Strathfield Local Planning Panel Meeting

Thursday, 1 March 2018

TO: Strathfield Local Planning Panel Meeting - 1 March 2018
REPORT: SLPP – Report No. 1
SUBJECT: 37-39 PUNCHBOWL ROAD & 90 WATER STREET, BELFIELD
DA NO. DA2017/101

Proposal: Demolition of all existing structures on the site, construction of eight (8) storey mixed use development comprising 61 residential apartments, 270m² of commercial/retail floor space at ground floor and three (3) storeys of basement car parking.

Figure 6: Extract of the architectural plans showing the ground floor plan

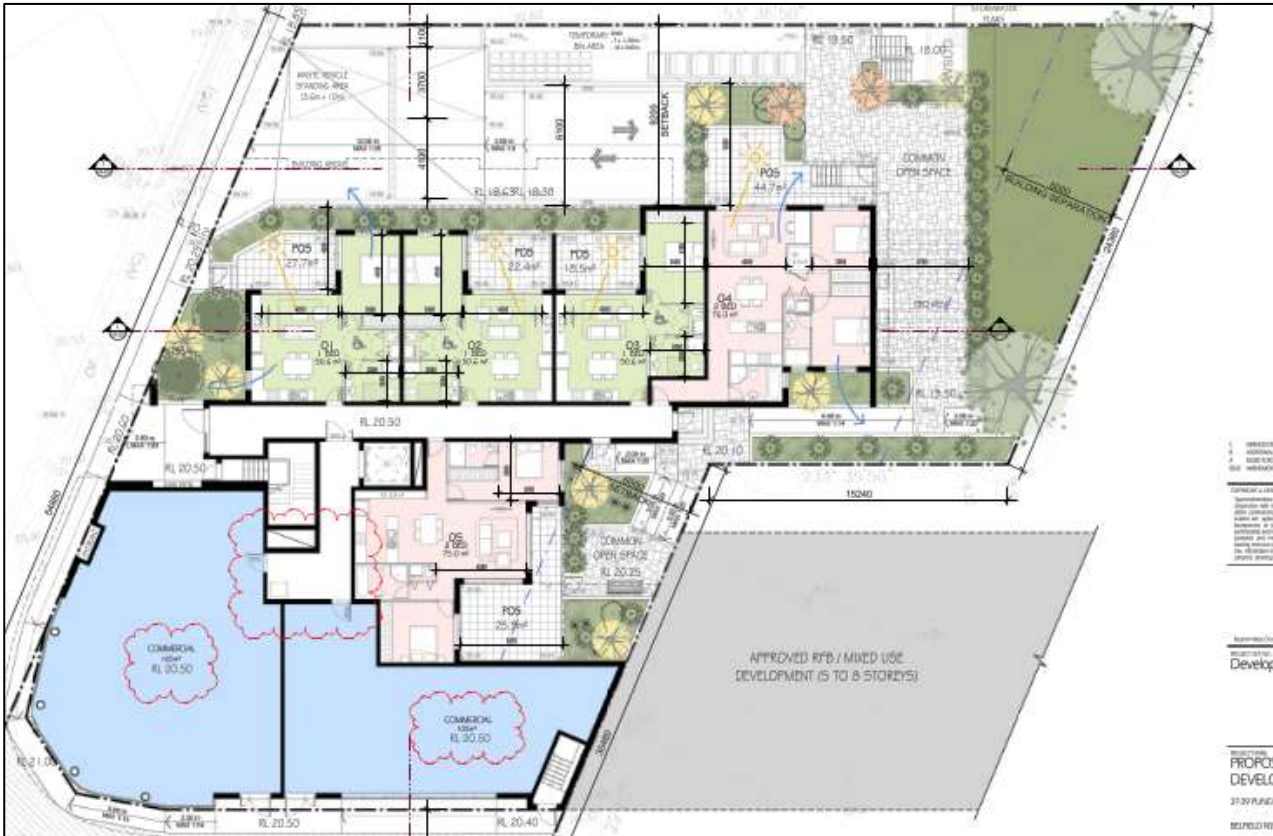
In accordance with 3F of the Apartment Design Guide (ADG) buildings up to a height of four (4) storeys are to provide a minimum 6m separation between habitable rooms and the nearest property boundary and a minimum 3m separation between non-habitable rooms and the property boundary. In this instance, the allotment immediately adjoins a lower density zoning (R3 – Medium Density) to the north and accordingly, an additional 3m separation is required to the northern elevation as per the ADG. The proposed development has been designed having consideration for the corner nature of the site and accordingly has two (2) frontages as per the illustration below extracted from the architectural plans:

The building provides a nil side setback to the front south-eastern portion of the site which aligns with the nil side setback provided by the approved development at 27-35 Punchbowl Road. The portion of the development immediately north of this follows a minimum 6m setback to the boundary which carries through all levels of the development. The windows to this portion of the development adjoin bedrooms and do not present adverse overlooking impacts to the site at 27-35 Punchbowl Road.
